Redevelopment of the Former Peel Centre, Colindale

Transport Statement Addendum

May 2015

Figure 3-1 - Workplace Zone Locations

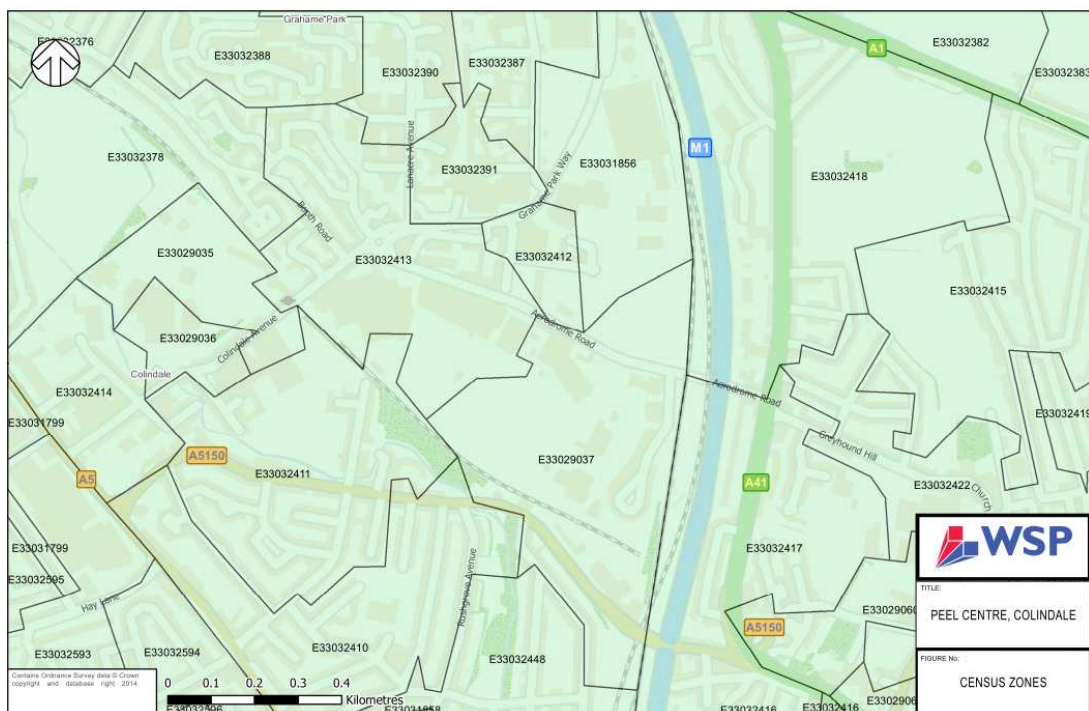
3.3.1 As part of the post-application discussions, TfL refer to the 2011 Census Workplace Zones E33029037 and E33032413 for the MPS Work Place trips analysis. The appropriate 2011 Census dataset to understand work travel is ‘WP703EW Method of travel to work (2001 specification) (Workplace population)’ – see Figure 3-1.

Tables 3-1 and 3-2 below summarise data for these two workplace zones. The locations of the zones are also shown below. Note Workplace Zone E33029037 contains some 1645 people travelling to work and E33032413 contains some 304. The MPS Future Transport Strategy document identified some 1090 staff commuters as indicated in Table 9.4 of the 2014 TA, so roughly half the number of employees in these zones. Other workers from these zones would have potentially different patterns from the MPS employees.

The conclusion that is drawn from this comparison is that whilst the review of the Census data is useful and shows there are similarities in the figures, the MPS specific Journey to Work survey data represents the best available information to establish existing MPS travel patterns. The empirical surveys in 2012 establish total person and vehicle trips and the MPS data is only being used for non-car mode.
